STATE OF NORTH CAROLINA
DEPARTMENT OF TRANSPORTATION

July 13, 2018

Subject: Modification Request for USACE Individual Permit, Section 401 Water Quality Certification, Neuse Riparian Buffer Authorization and CAMA Major Development Permit for the proposed improvement of US 17 from south of Belgrade at SR 1330/SR 1439 to the New Bern Bypass, in Onslow, Jones and Craven Counties. TIP No. R-2514 B, C & D, COE Action ID: SAW-2008-00528. WBS 34442.1.3.

**PERMIT DRAWING
SHEET 2 OF 84**

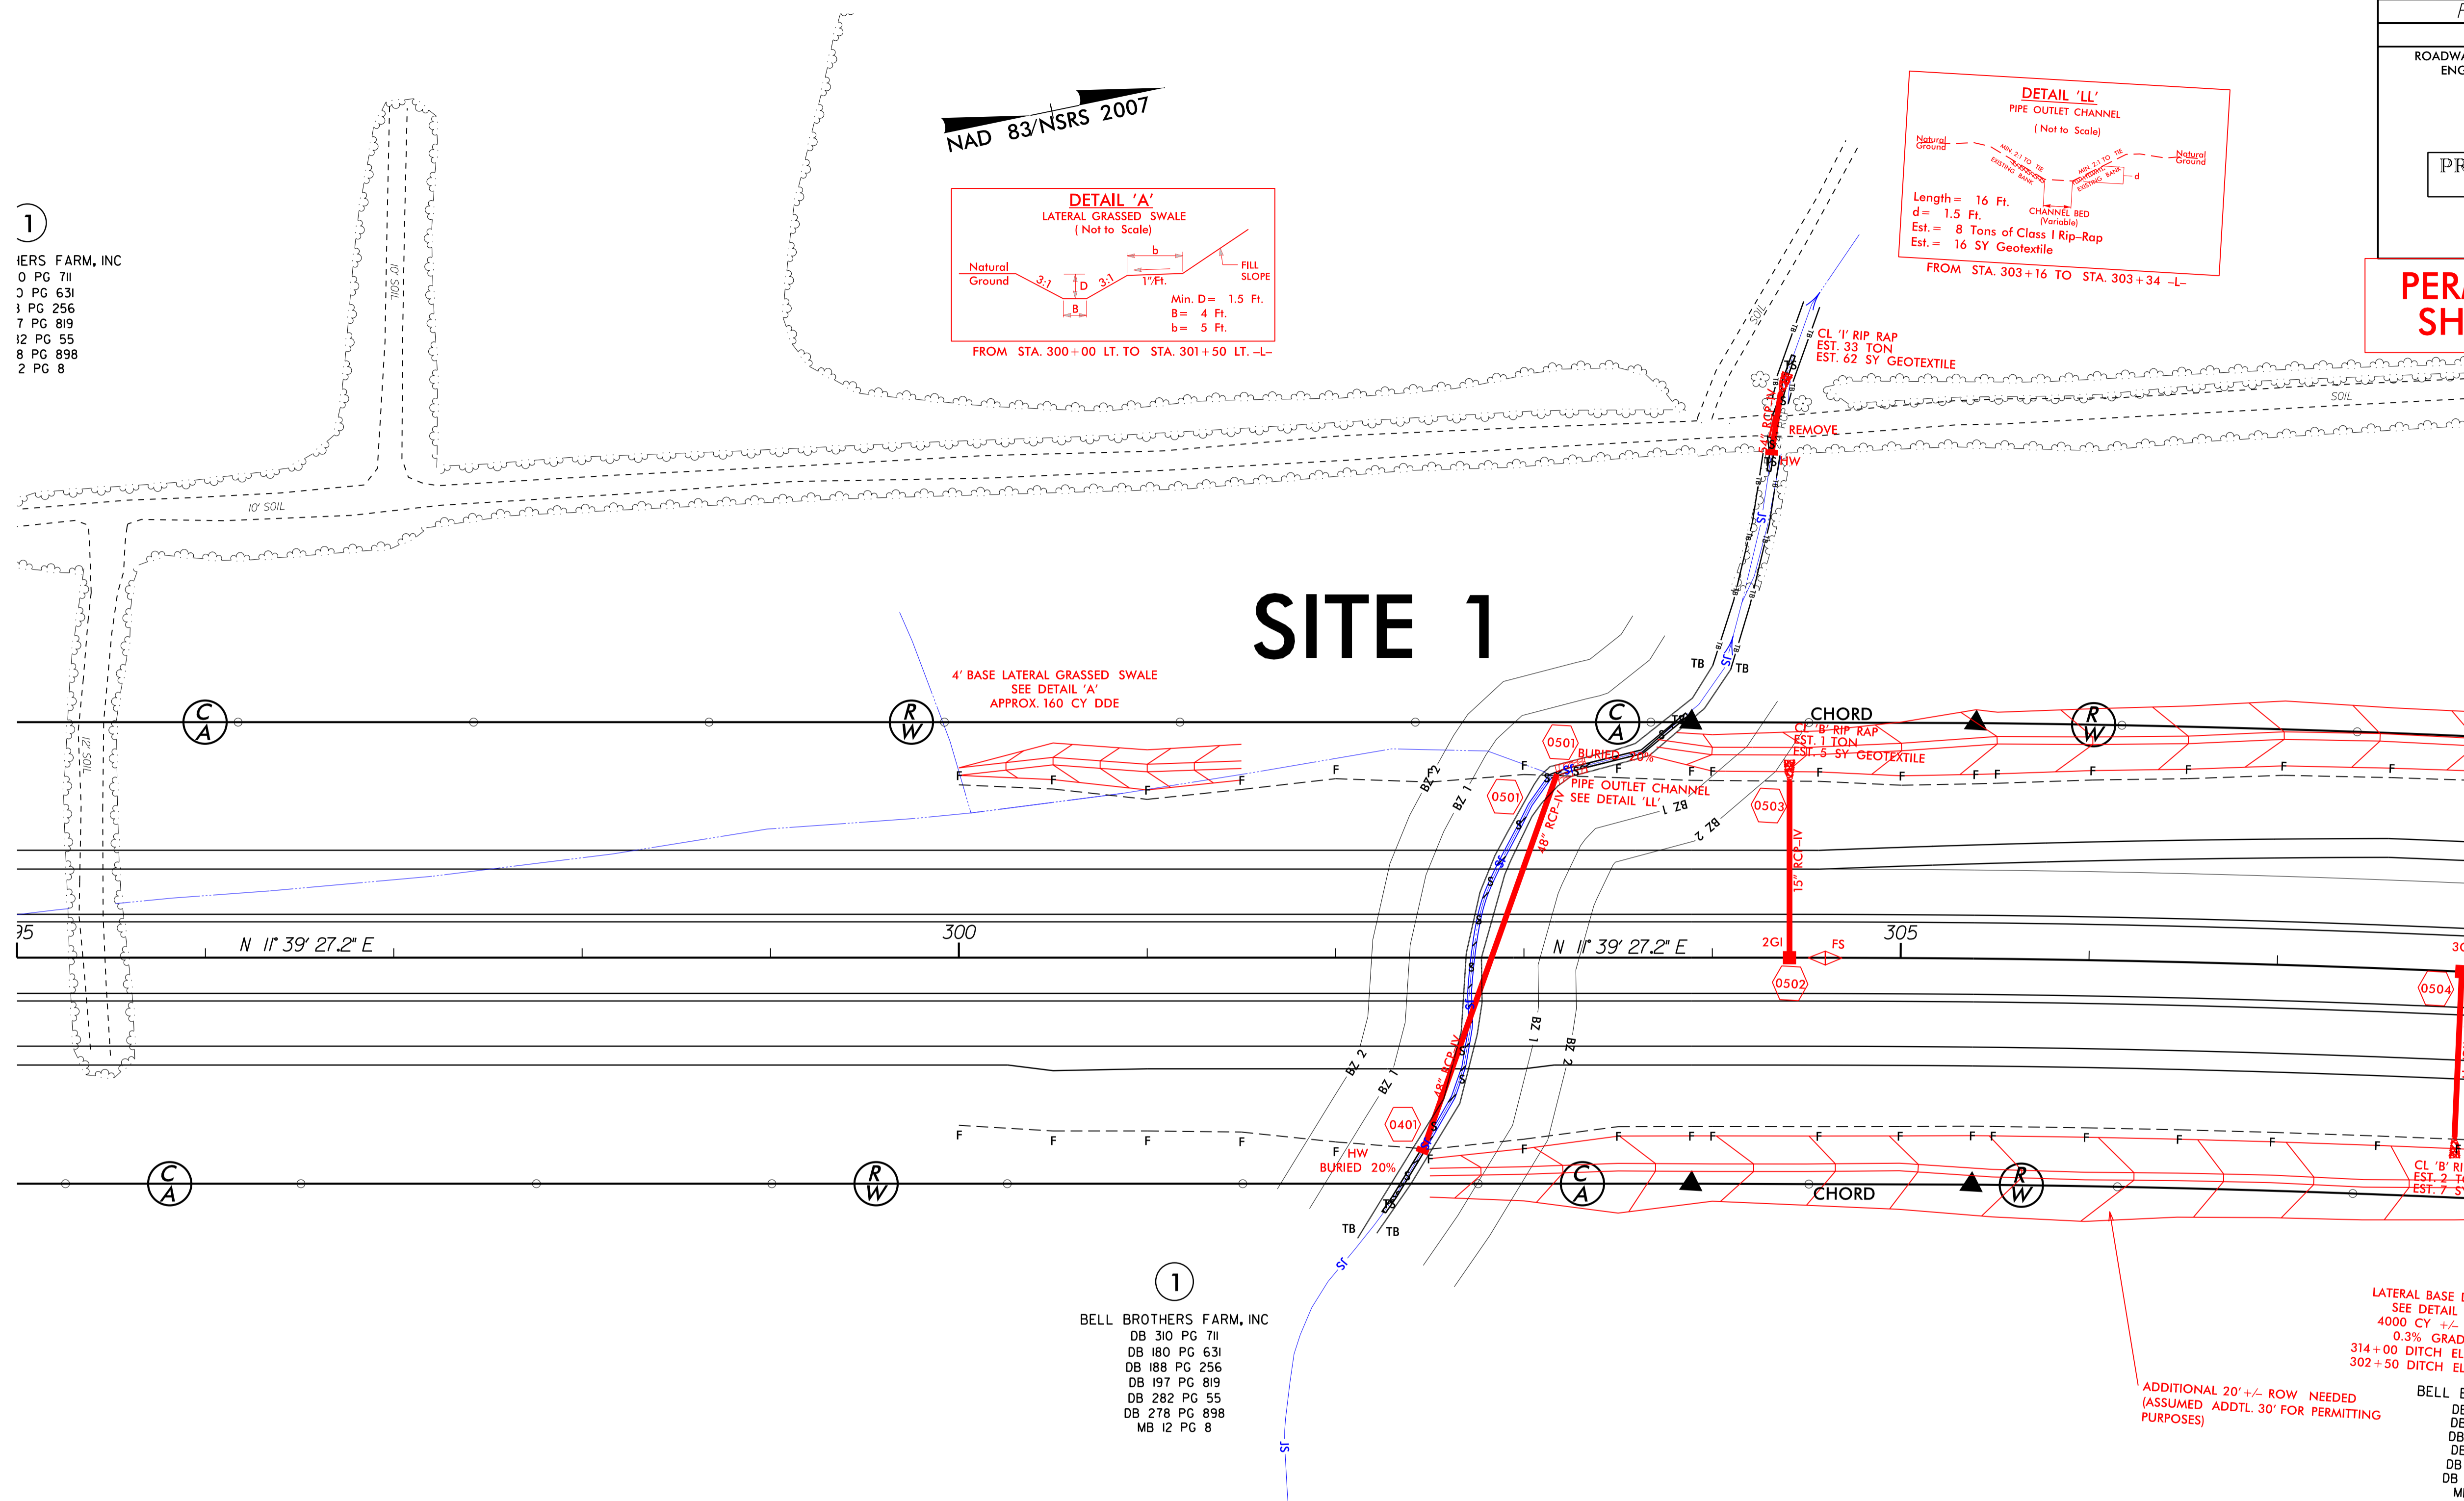
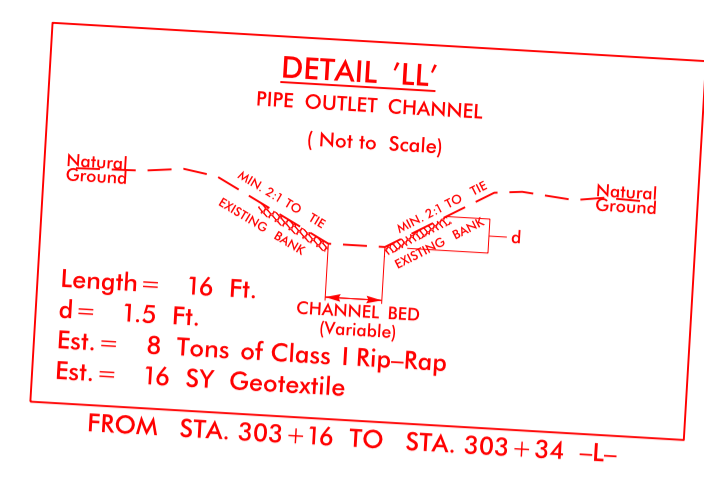
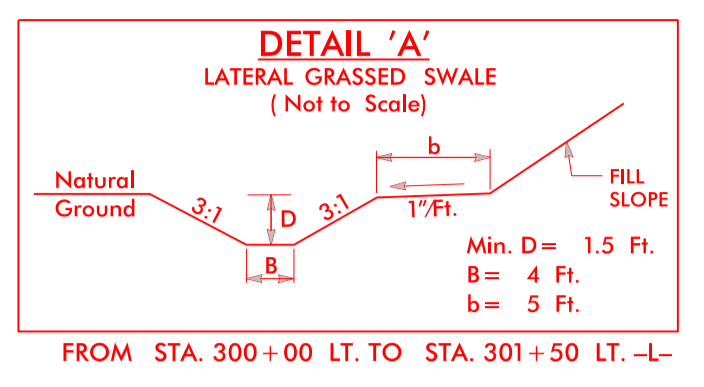
To resolve the issue and drain the standing water caused by the roadway fill, we are proposing ditches to drain from the problem area toward the jurisdictional stream approximately 1200' south, which is Site 1 in the permit drawings for R-2514D. The proposed ditch on the left side of the -L- line will be at 0.26% grade from 303+75 to 316+20 Lt. The proposed ditch on the right side of -L- will be at 0.3% grade from 302+50 to 314+00 Rt. The ditches are proposed to be 4' base swales with 3:1 side slopes to maximize stormwater storage. Downstream of the 48" RCP crossline at 303+00, an existing 24" RCP driveway pipe is proposed to be replaced with a 54" RCP to further resolve the drainage issues.

These modifications will require additional impacts to the stream and riparian buffers at this site, but no additional impacts to wetlands. Excavation through the riparian buffers is necessary in order to achieve an elevation low enough to drain the ponding that is occurring on the private properties. Permanent channel impacts increase by 127 feet. Streambank stabilization increases by 16 feet. Temporary channel impacts increases by 9 feet. Permanent surface water impacts increase by 0.01 acre. There are an additional 5,306 sq. ft. of buffer impacts in Zone 1, and 3479 sq. ft. in Zone 2, for a total increase of 8,785 sq. ft. Revised permit drawings are attached depicting these changes.

ADDITIONAL 20' +/- ROW NEEDED
(ASSUMED ADDTL. 30' FOR PERMITTING PURPOSES)

**PERMIT DRAWING
SHEET 3 OF 84**

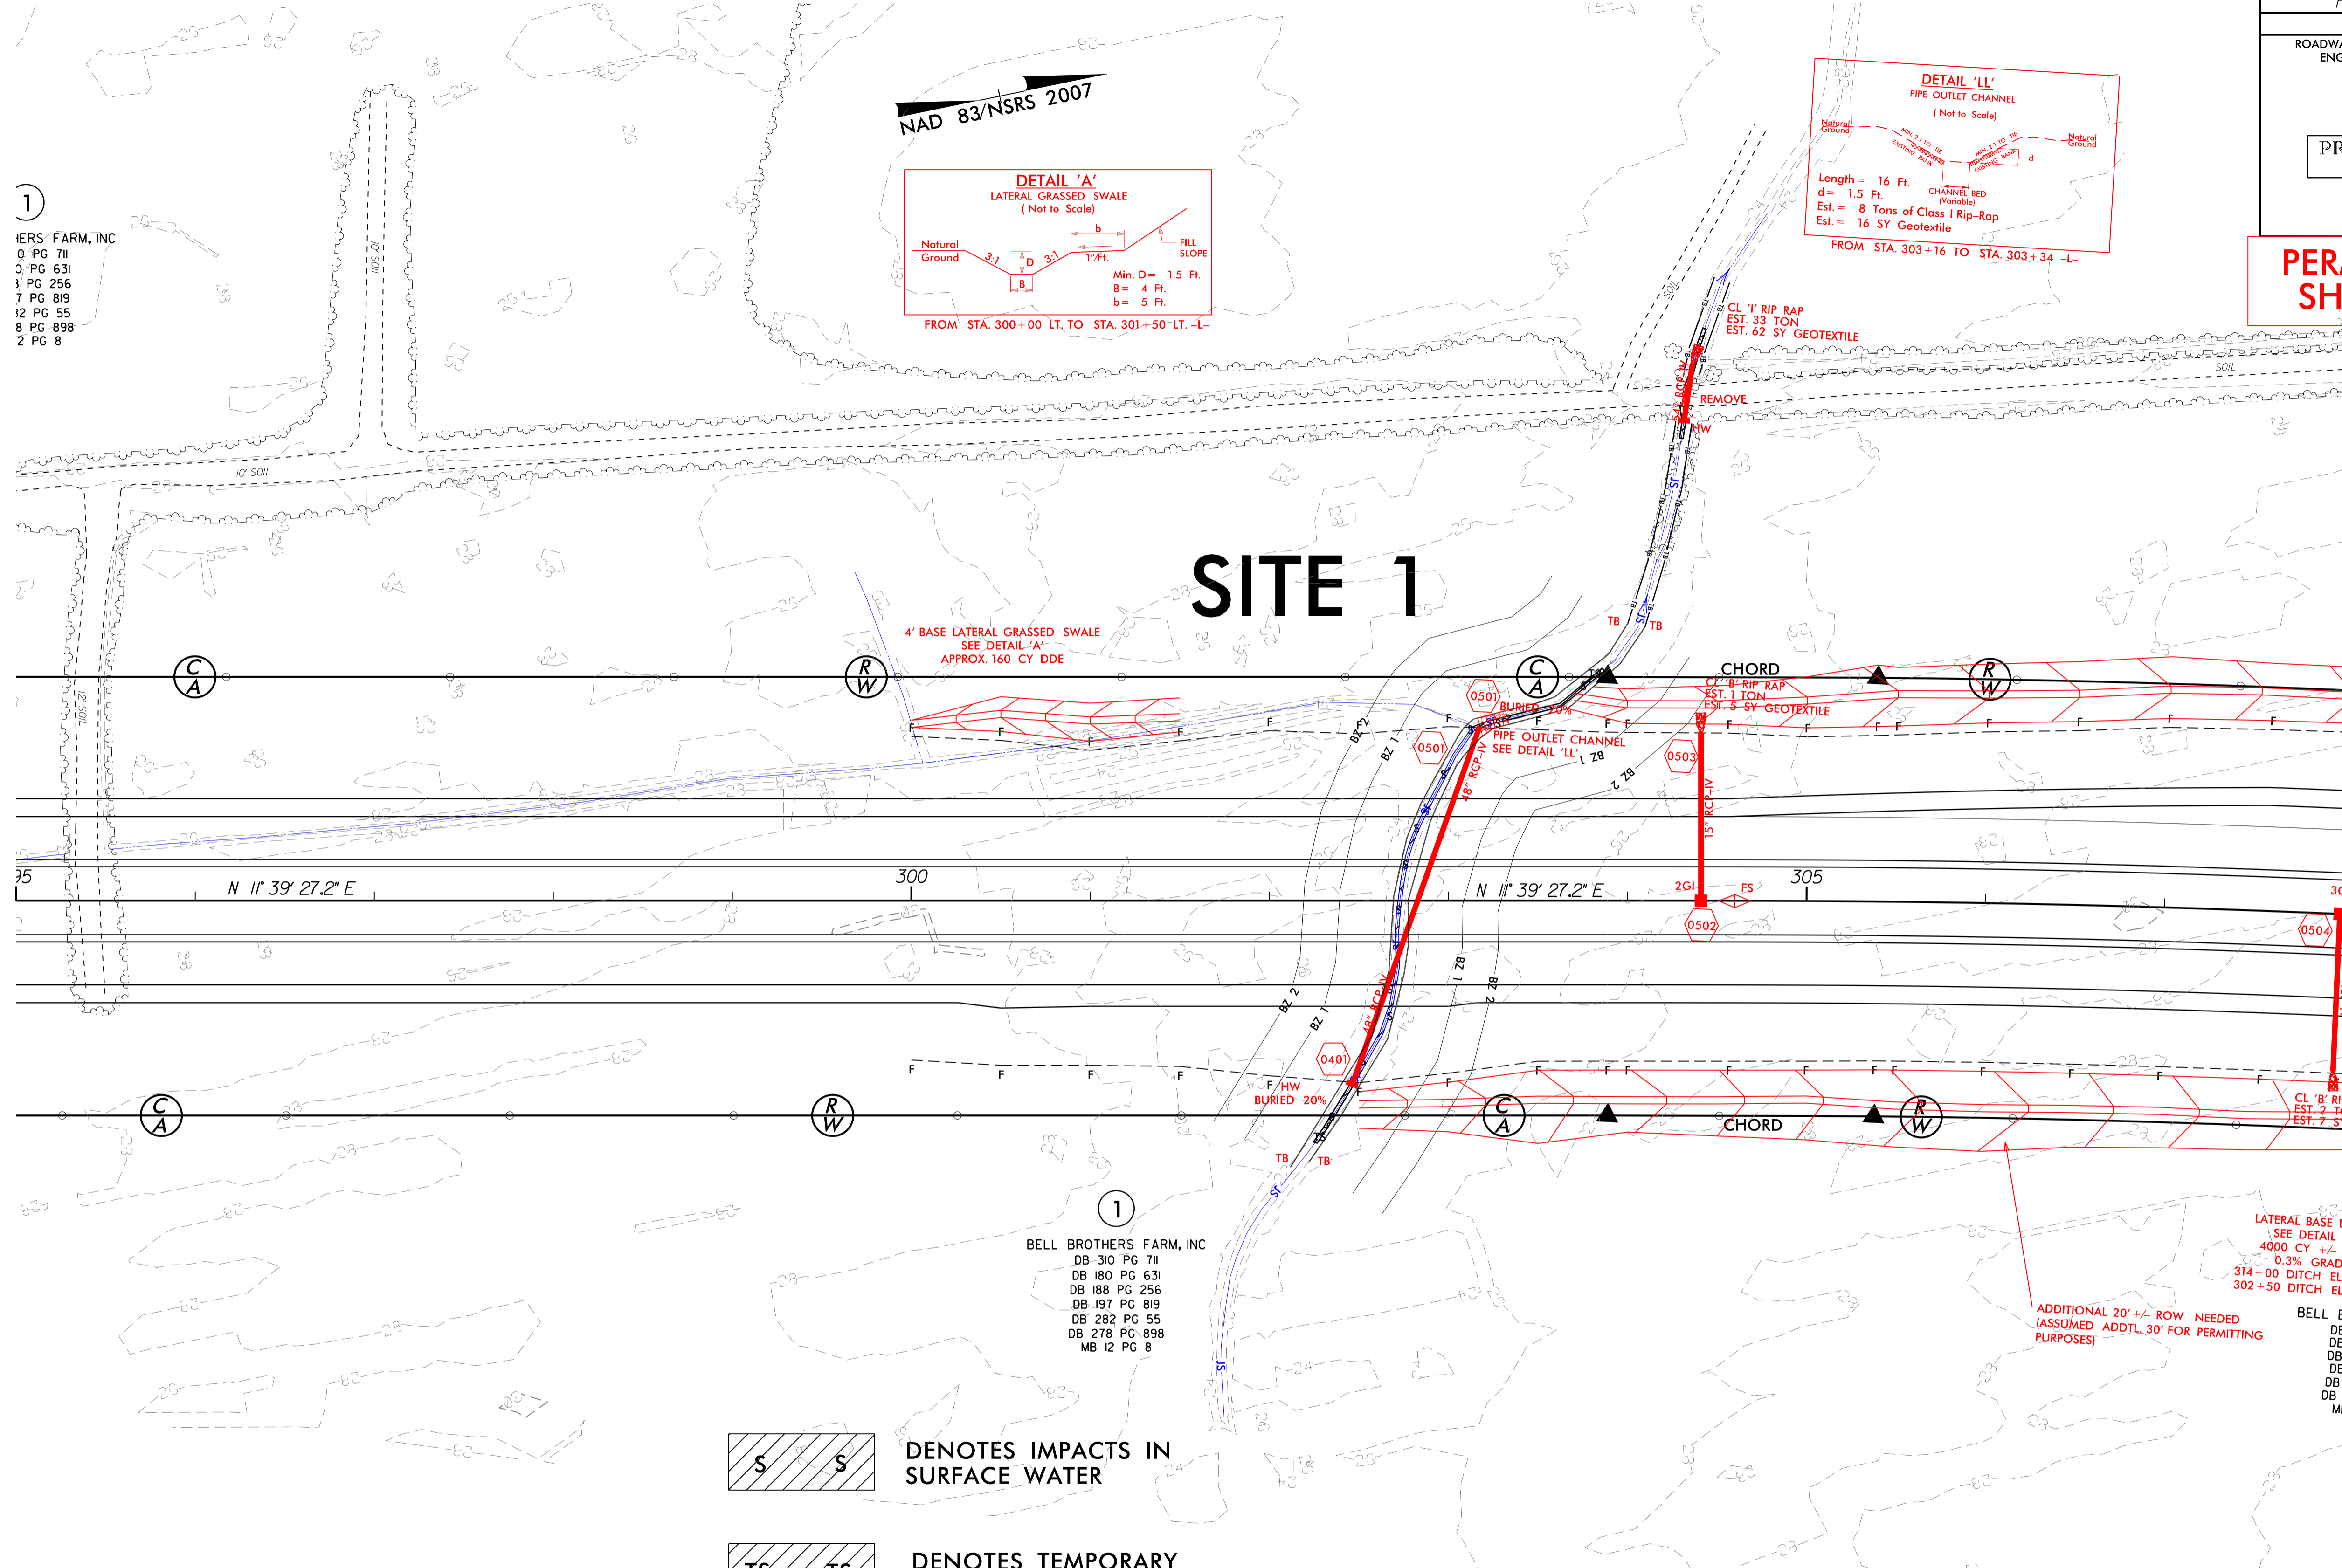
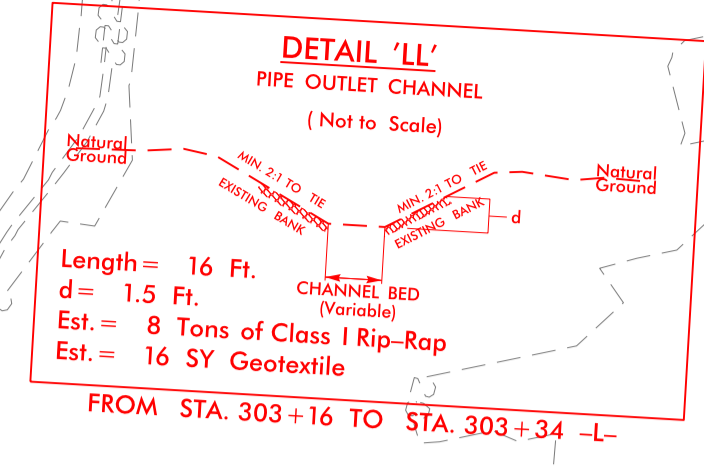
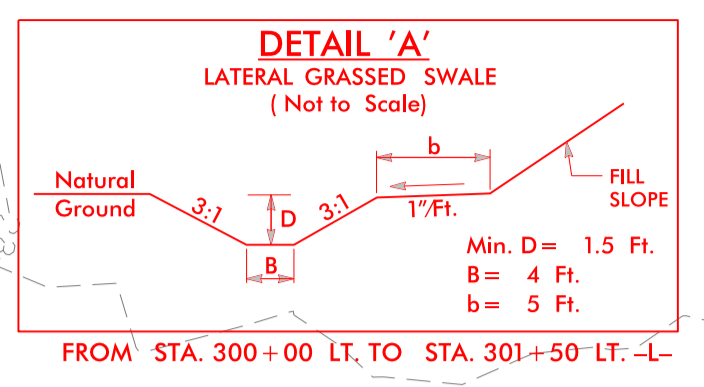
4' BASE LATERAL GRASSED SWALE
SEE DETAIL 'A'
APPROX. 160 CY DDE

PIPE OUTLET CHANNEL
SEE DETAIL 'LL'
